# In support of Clause 154, Table 154.8, Transmitter Parameters, 100GBASE-ZR

Presenter: John DeAndrea

Affiliation: II-VI Incorporated

Table 154–8—100GBASE-ZR transmit characteristics

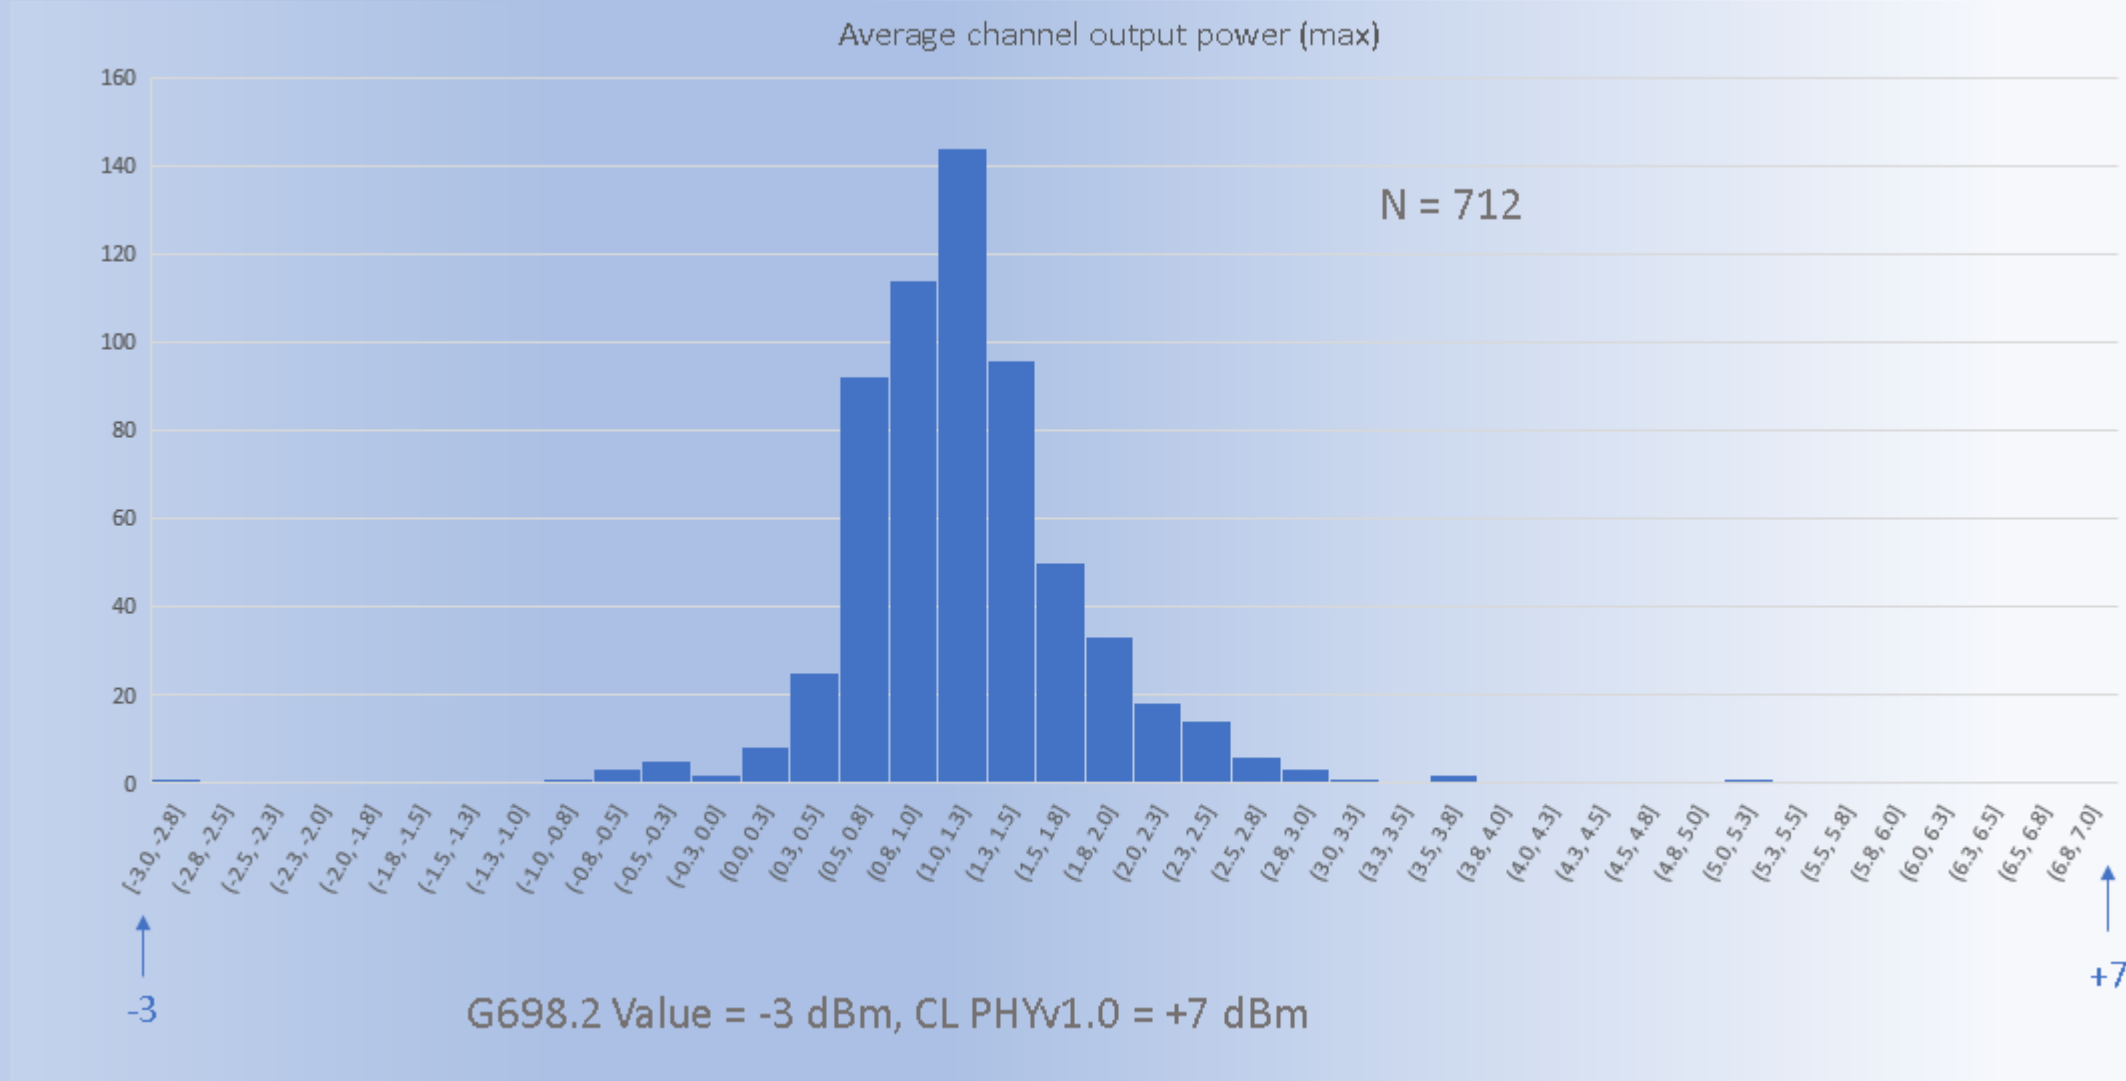
- Adopt average channel output power (max), +7 dBm
- Change table name to “Average Launch Power, Transmitter Disabled”
- Adopt -35 dBm for “Average Launch Power, Transmitter Disabled”
- Adopt Skew between the two polarizations (max) , 6 ps

# Average channel output power (max)

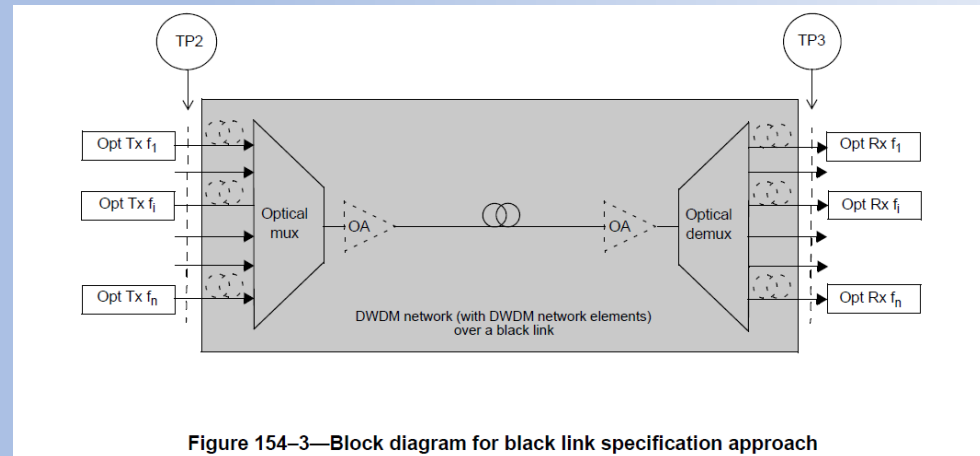
- Distribution data shows values within the range of -3 to +7 dBm
- High power transmitters allow complete passive link implementations for the black link
- The +7 dBm power limit may require attenuator be added to PMD output when Booster EDFA is installed in the black link

## Average launch power of OFF transmitter each lane(max)

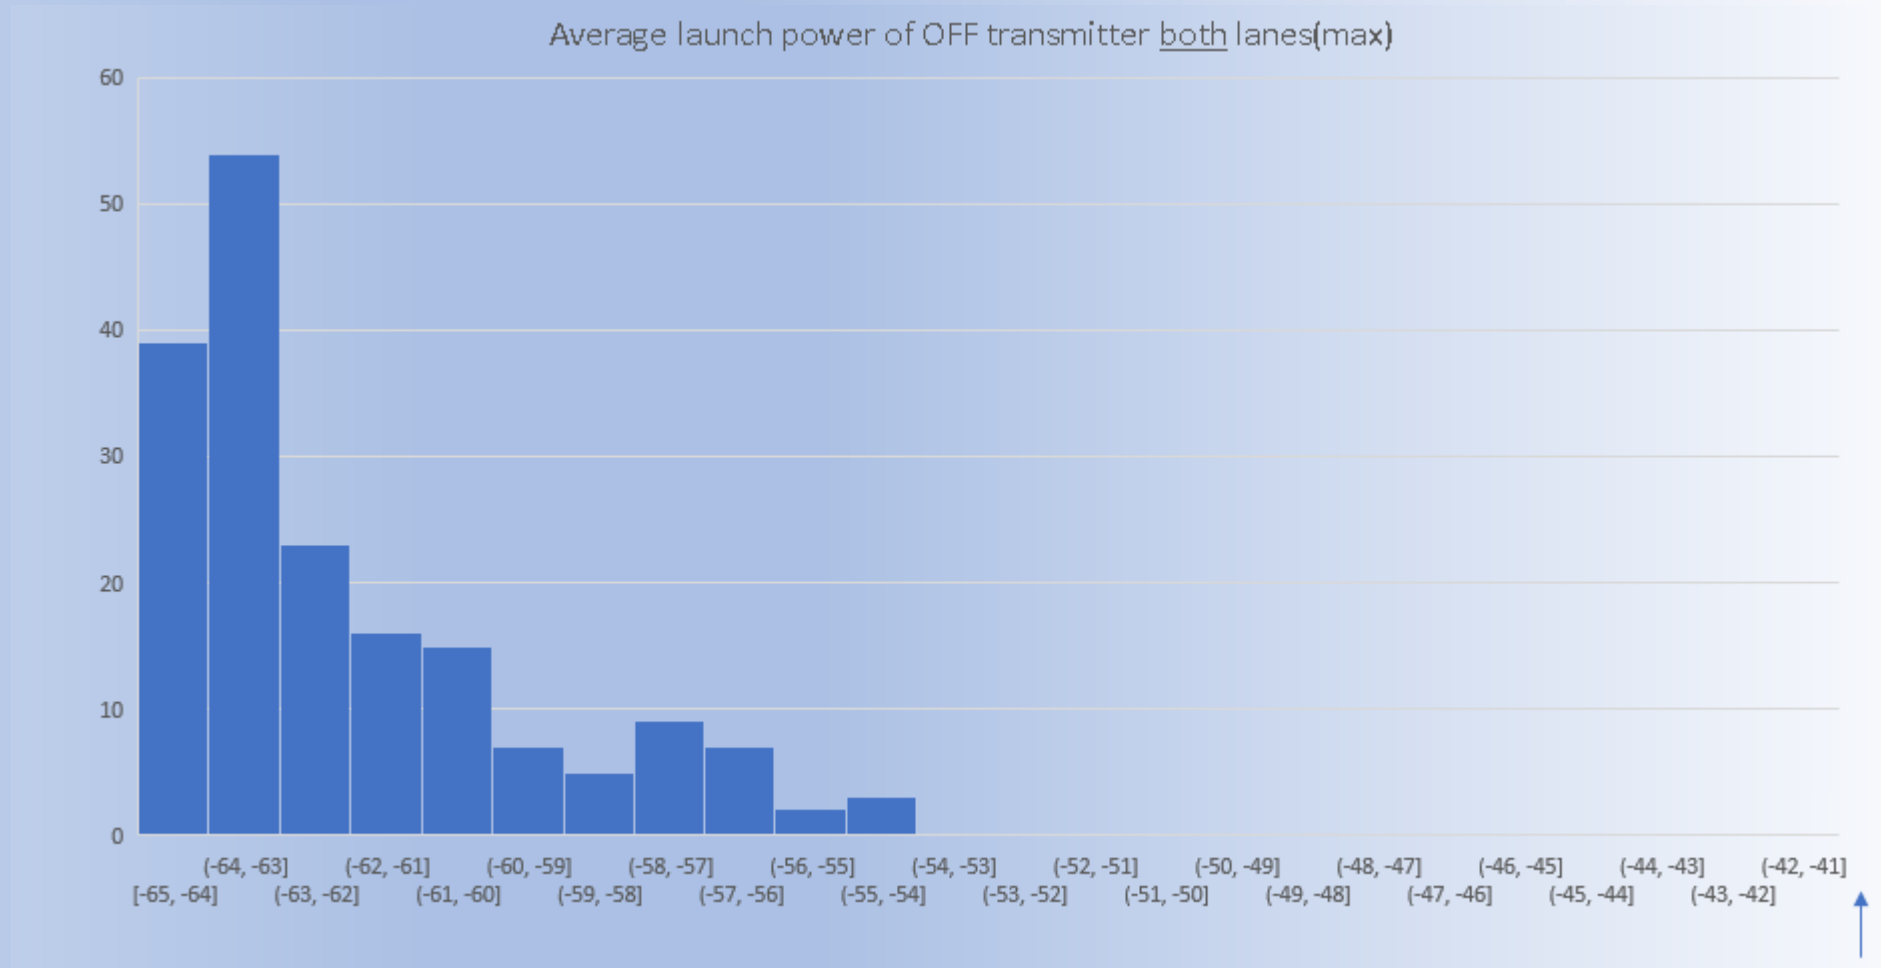
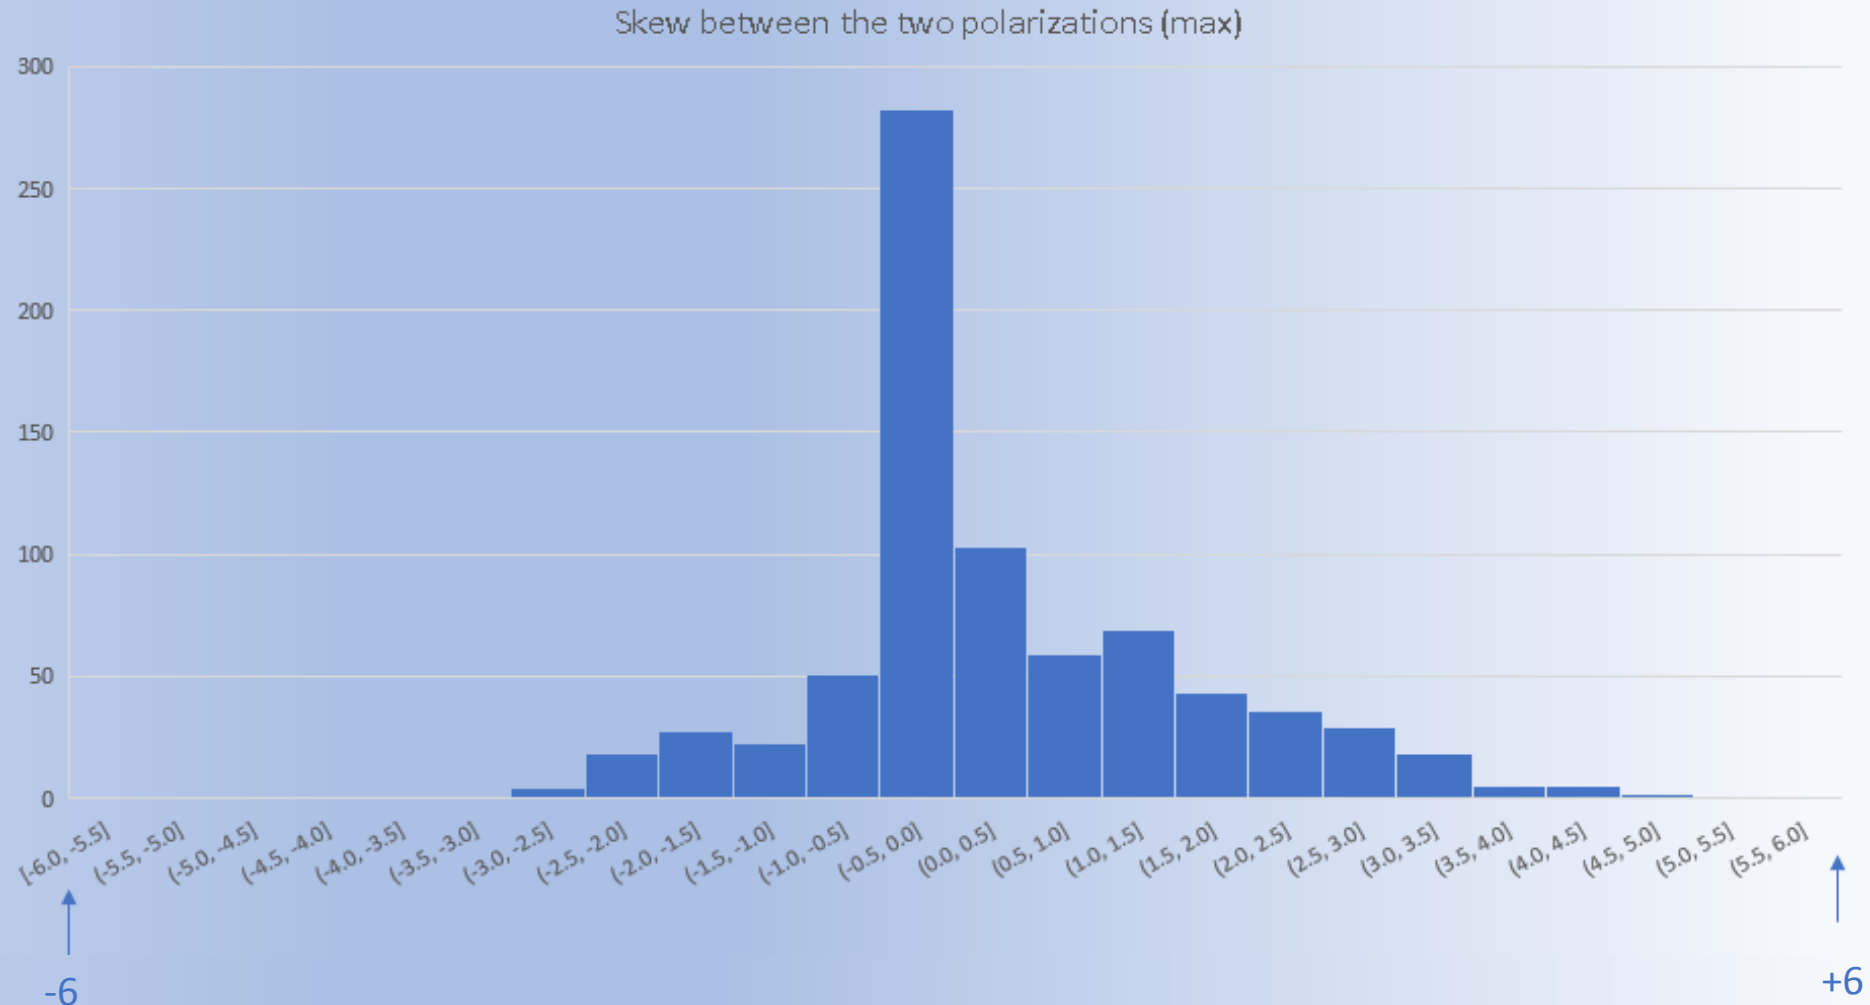
Note: Production data taken for Transmit power of BOTH lanes

- Distribution data shows values below -40 dBm
- Production test would test both lanes, not one at a time
- Suggest we change definition to “Average Launch Power, Transmitter Disabled”
- Suggest Industry number, -35 dBm
